IBC-Structural

2022 GROUP B PROPOSED CHANGES TO THE I-CODES ROCHESTER COMMITTEE ACTION HEARINGS

2021-2022 Code Development Cycle, Group B (2022) Proposed Changes to the 2021 *International Codes*

TENTATIVE ORDER OF DISCUSSION 2022 PROPOSED CHANGES TO THE INTERNATIONAL BUILDING CODE - STRUCTURAL

FIGURE 1609.3(1) BASIC DESIGN-WIND SPEEDS, V , FOR RISK CATEGORY I-BUILDINGS AND OTHER STRUCTURES

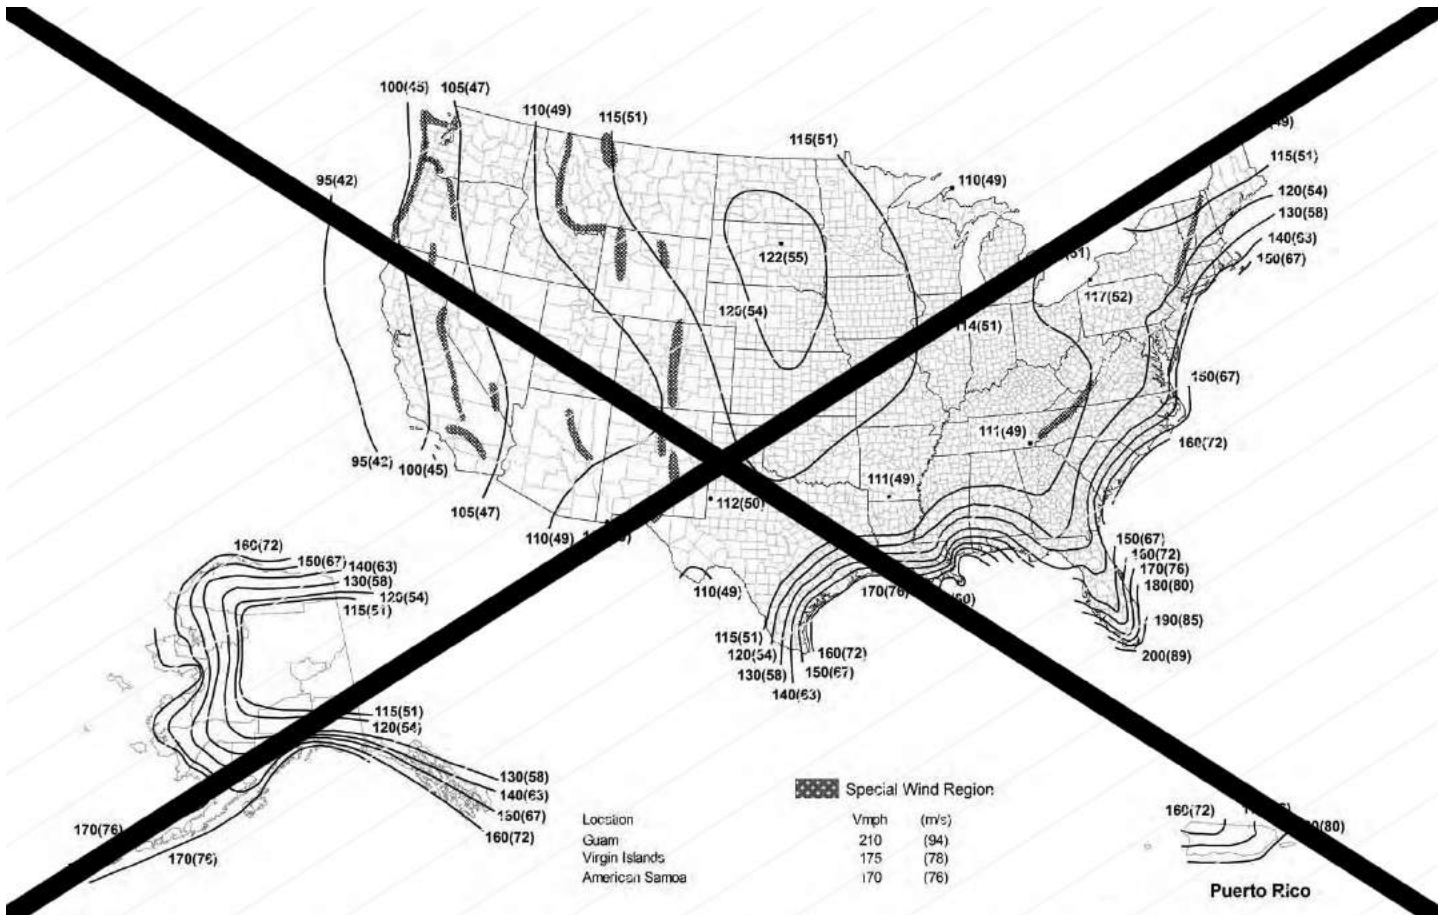
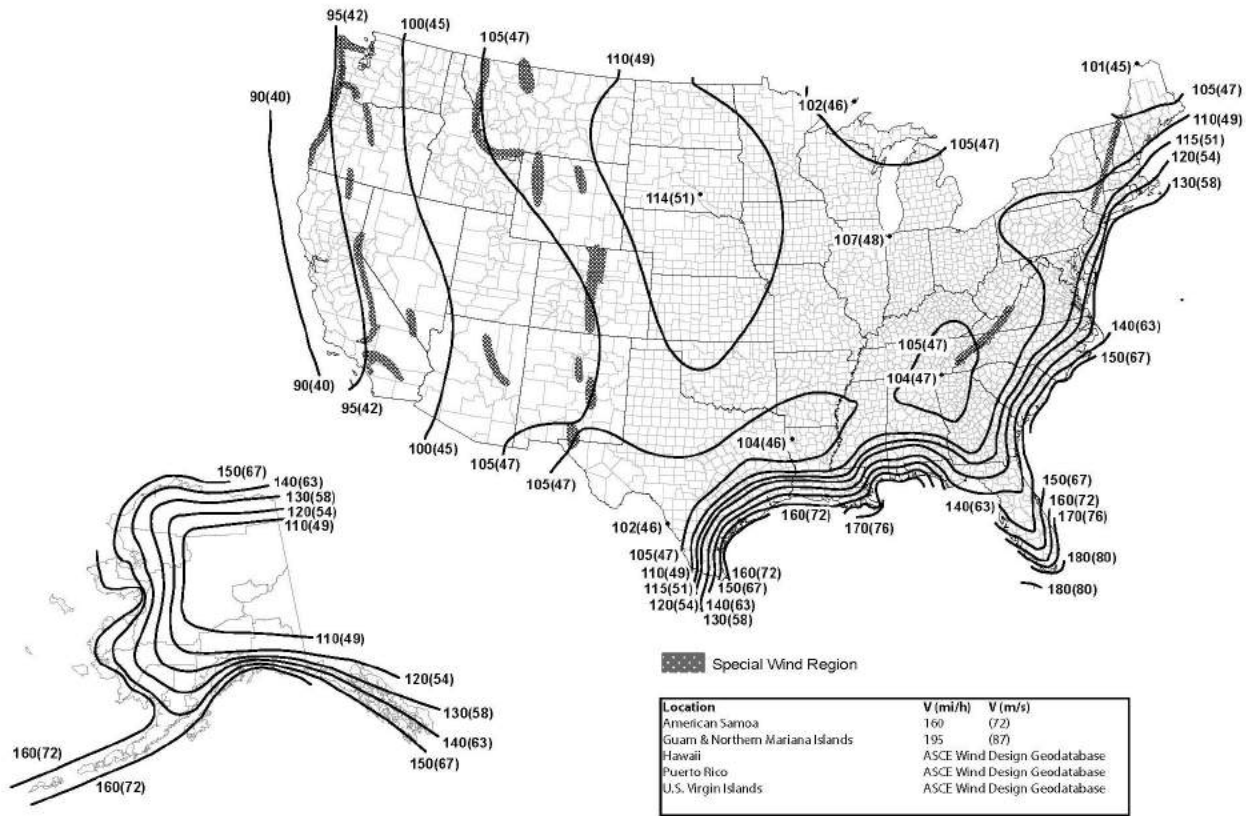
For *Risk Category II* buildings and structures and *Risk Category III* buildings and structures, except health care facilities, the windborne debris region shall be based on Figure ~~1609.3(1)~~ 1609.3(2). For *Risk Category III* health care facilities, and *Risk Category IV* buildings and structures and *Risk Category III* health care facilities, the windborne debris region shall be based on Figure ~~1609.3(2)~~ 1609.3(3) and Figure 1609.3(4), respectively .

1504.6 Edge systems for low-slope roofs. Metal edge systems, except gutters and counterflashing, installed on built-up, modified bitumen and single-ply roof systems having a slope less than 2 units vertical in 12 units horizontal (2:12) shall be designed and installed for wind loads in accordance with Chapter 16 and tested for resistance in accordance with Test Methods RE-1, RE-2 and RE-3 of ANSI/SPRI ES-1, except basic design wind speed, V , shall be determined from Figures 1609.3(1) through ~~1609.3(12)~~ 1609.3(4) as applicable.

Table 1504.2: Updates the pointer to the maps in 1609.3(1)-(4).

FIGURE: Comparison of ASCE/SEI 7-22 basic wind speeds for Risk Category II (700 Year MRI) to ASCE/SEI 7-16. (Courtesy ARA)

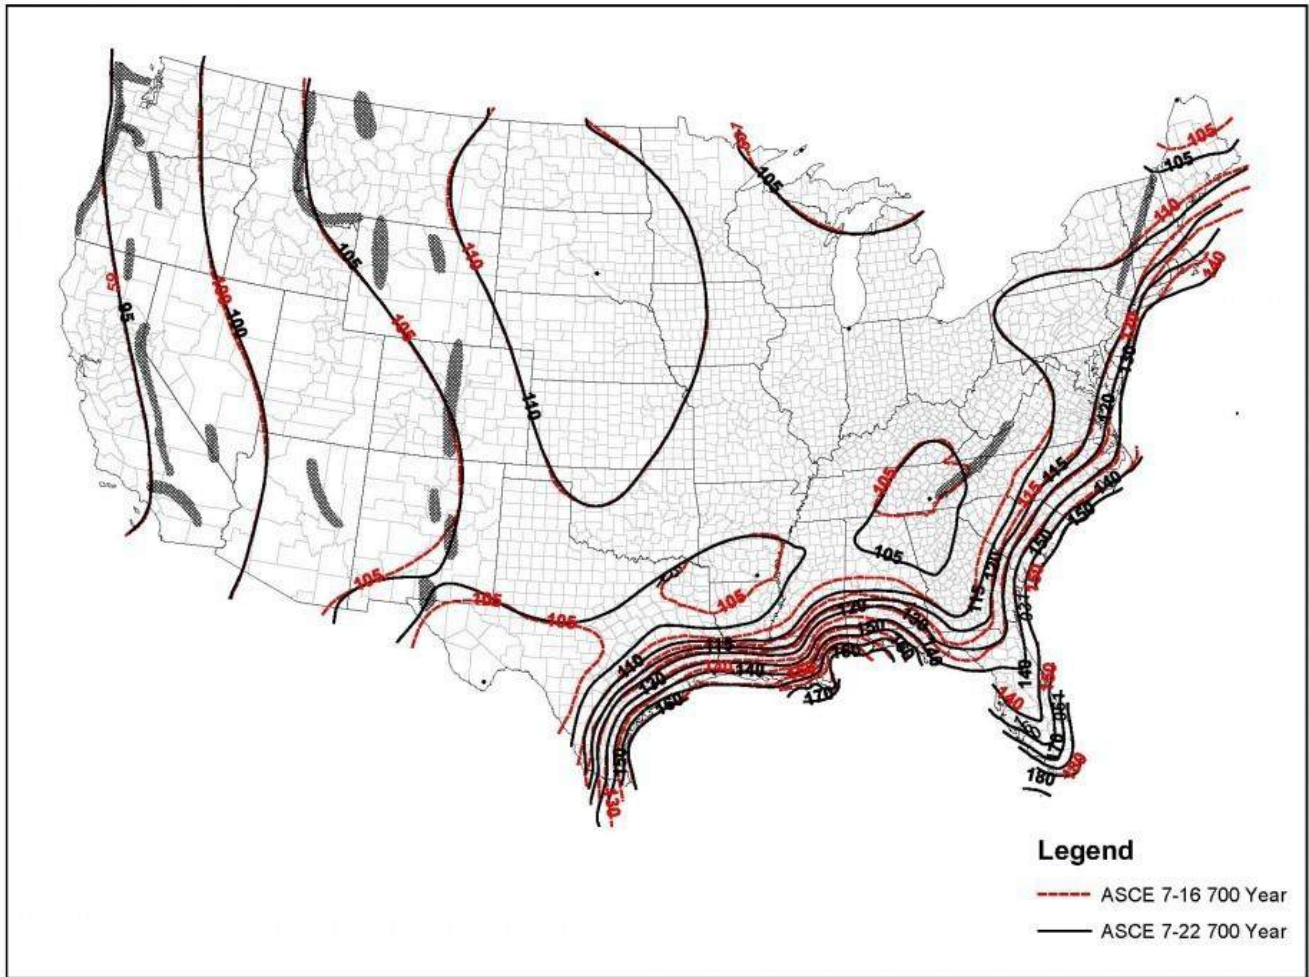
Although the wind speeds do increase in some locations along the hurricane coastline, the higher wind speeds influence less than 3% of the United States. The wind speeds decrease in most areas along the hurricane coastline (as shown by the wind speed contours moving closer to the coastline), while in the Gulf Coast area of the Florida Panhandle the contours extend further inland, which indicates higher wind speeds for this area. And most of the rest of the continental United States the speeds do not change and therefore the cost of construction will be unchanged; see the Risk Category II map below that compared ASCE 7-22 to ASCE 7-16. ASCE 7 Wind speeds are available at the ASCE 7 Hazard Tool (<https://asce7hazardtool.online/>), which is free to all users, to view and compare various locations.

Figure 7. Locations where design for tornado loads is not required for a Risk Category III building or other structure having an effective plan area $A_e = 100,000 \text{ ft}^2$, located in Exposure B (top) and Exposure C (bottom).

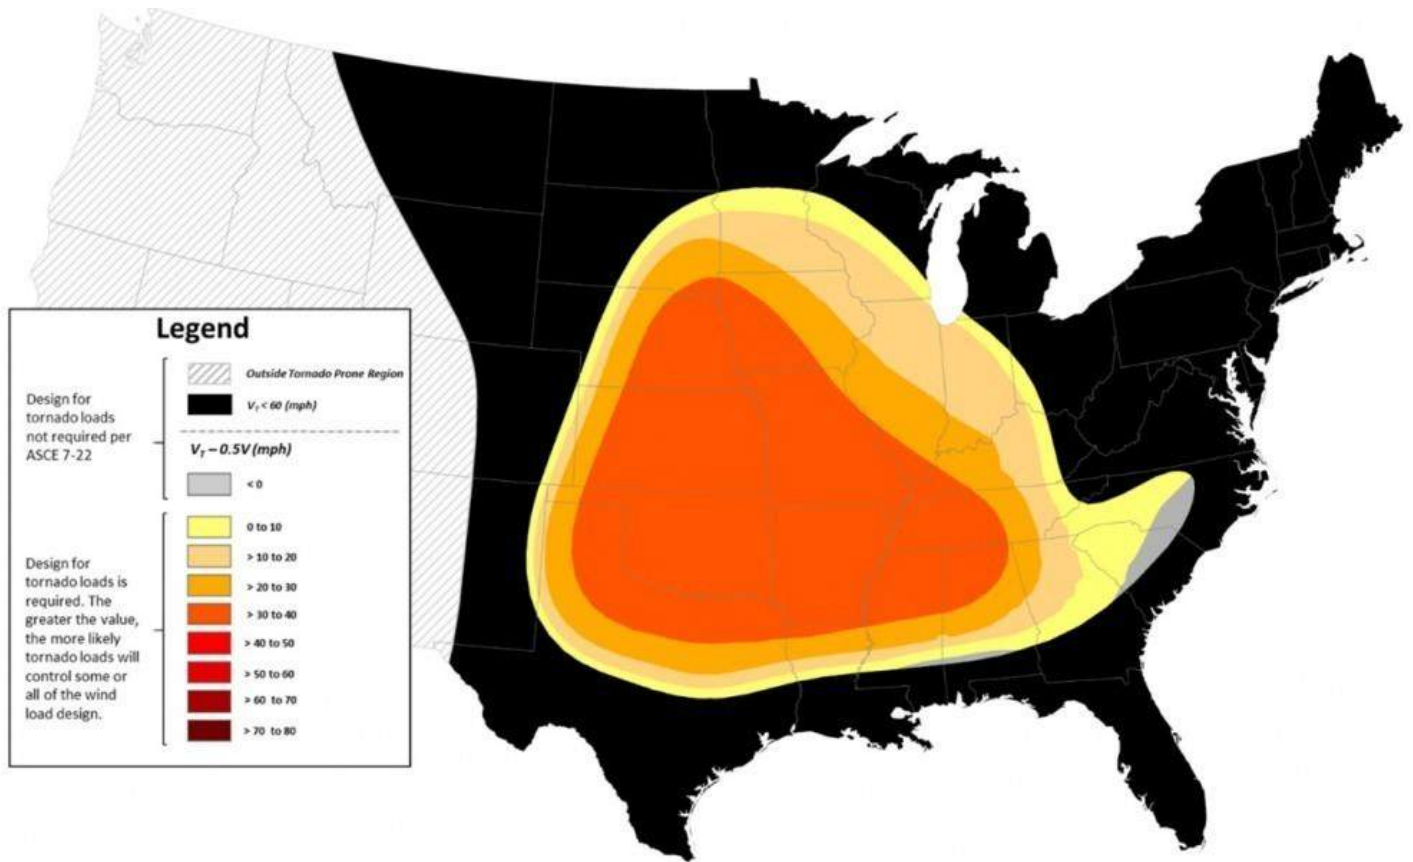
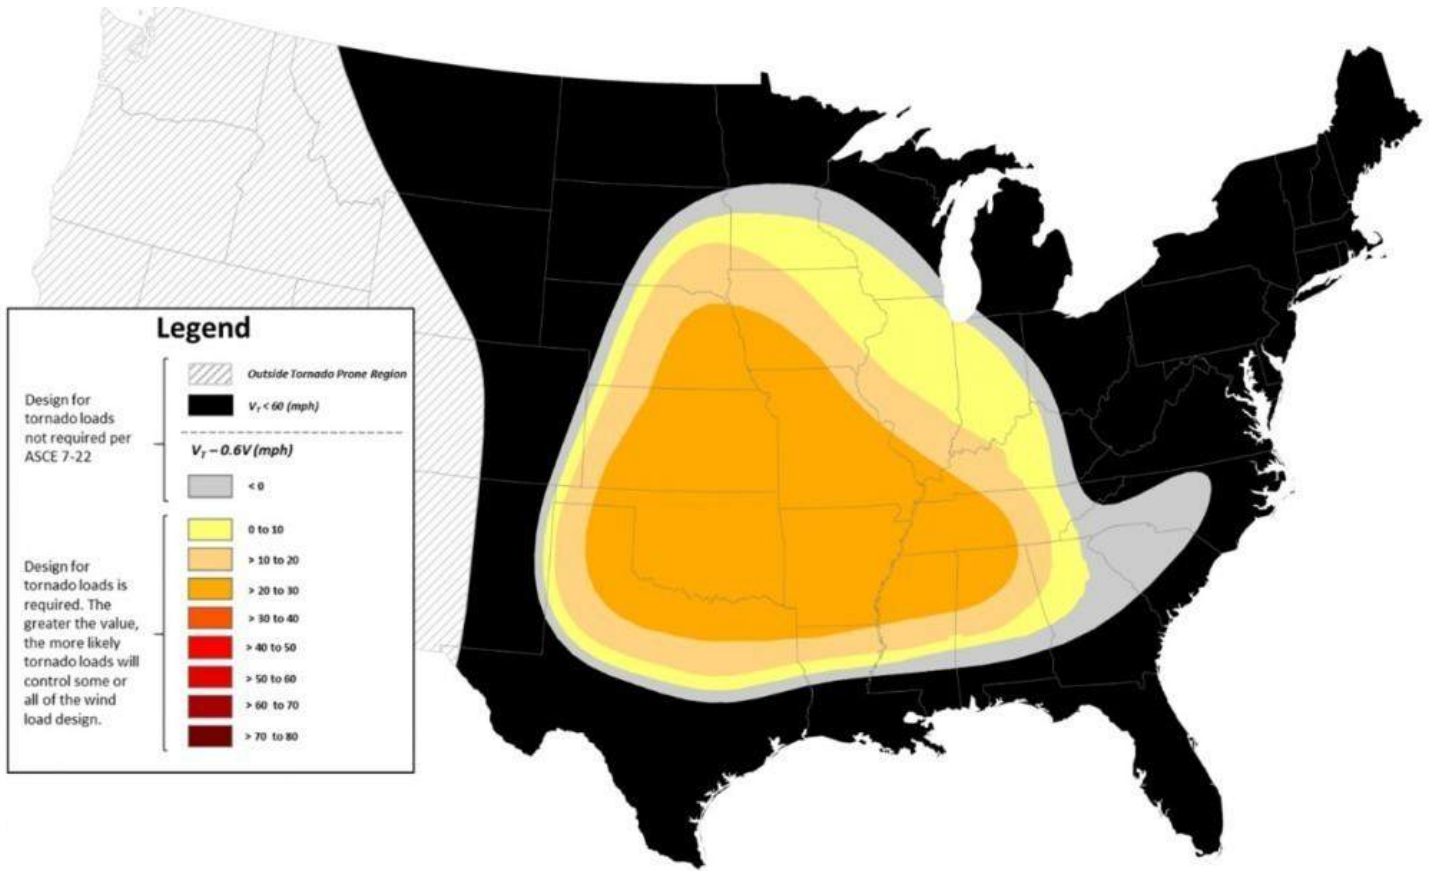
For a medium-sized Risk Category III building, the tornado speeds are less than 60 mph across much of the tornado prone region (Figure 7). Tornado loads are required only in the areas shaded with the warm colors, which spans roughly between north Texas, central Minnesota, and the central Carolinas. In contrast, tornado loads are required across most of the tornado-prone region for very large Risk Category IV facilities, except New England and small areas of south Florida and south Louisiana for Exposure C (Figure 8). In both figures, the darker reds indicate areas that tornado loads are more likely to exceed wind loads. In general, tornado loads are more likely to control at least some element(s) of the wind load design for buildings and other structures that have one or more of the following characteristics:

Figure 8. Locations where design for tornado loads is not required for a Risk Category IV building or other structure having an effective plan area $A_e = 1,000,000 \text{ ft}^2$, located in Exposure B (top) and Exposure C (bottom).

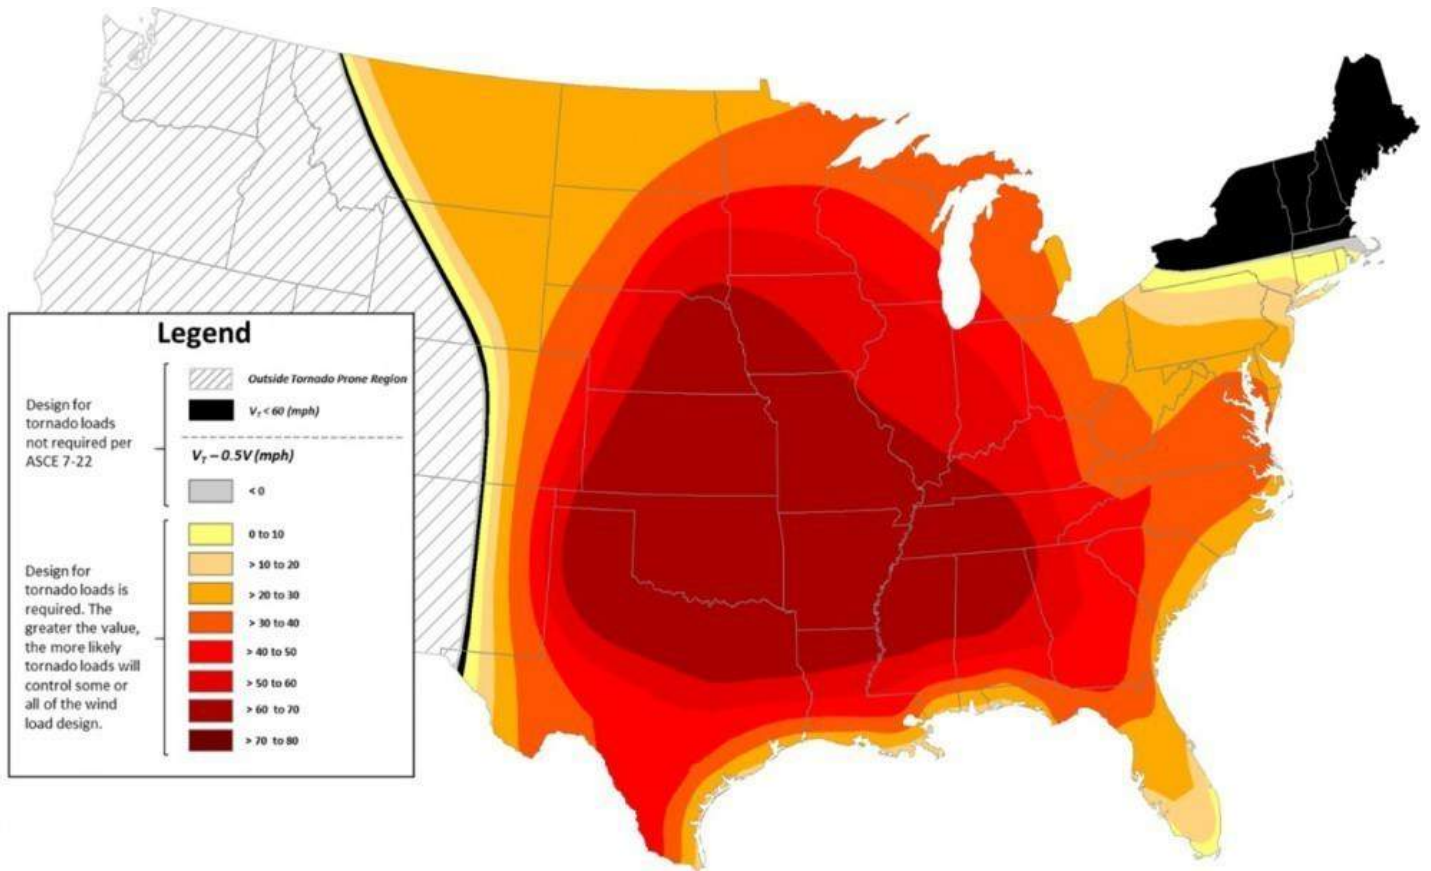
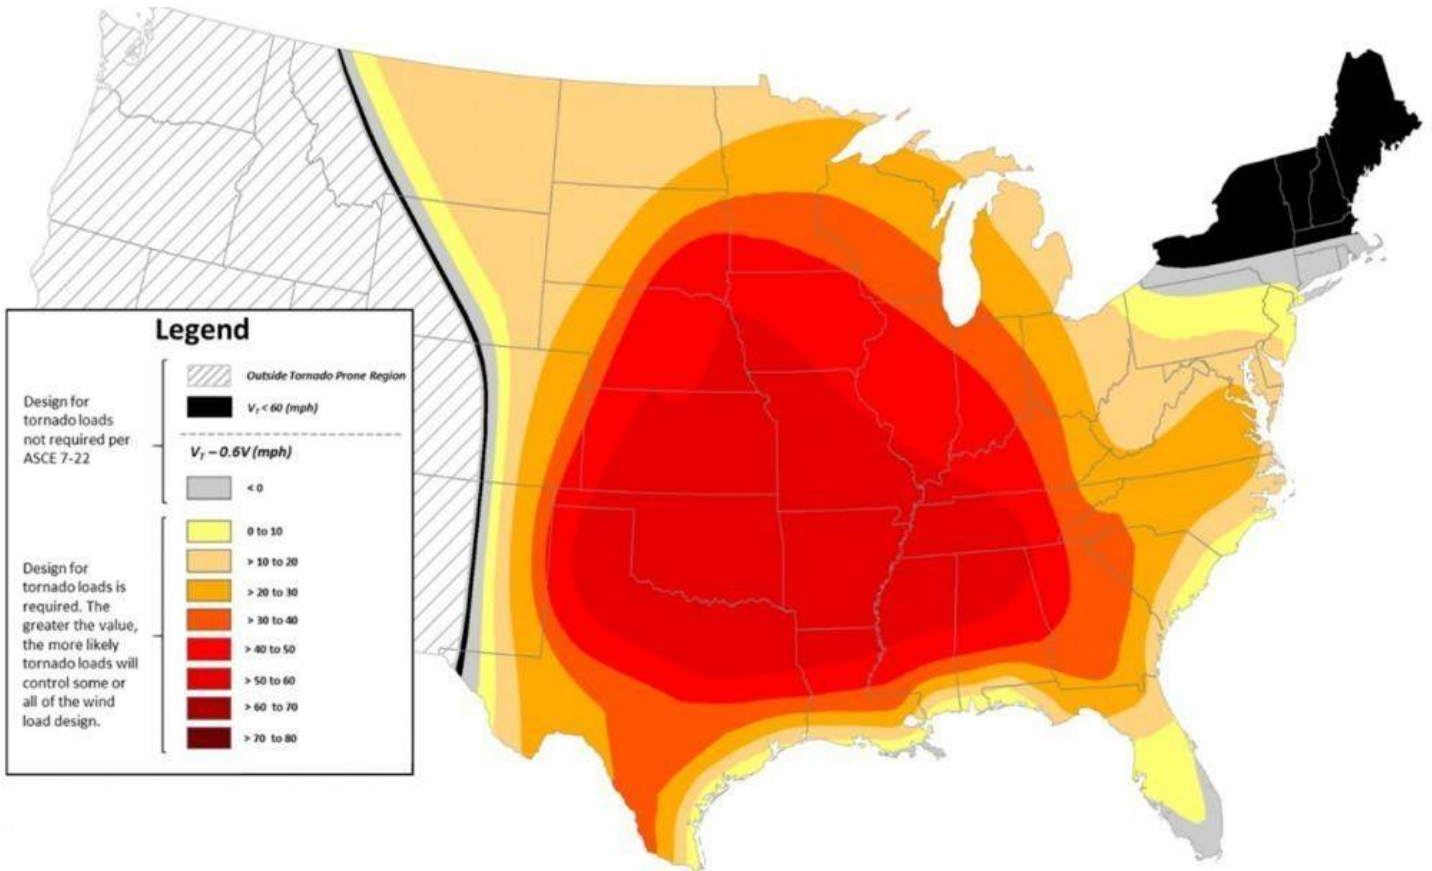
Maps were created to show where design for tornado loads is not required, based on the tornado speed criteria in the previous paragraph. Examples for a medium size Risk Category III facility and a very large Risk Category IV facility are shown in Figures 7 and 8, for both Exposures B and C. At locations where the tornado speed is greater than the specified percentage of the basic wind speed, design for tornado loads is required but may still not control. This is because the net pressure loading patterns on a building are different for tornadic versus non-tornadic winds, due to the differences in wind and wind-structure interaction characteristics which are reflected by factors 4 through 8 above.
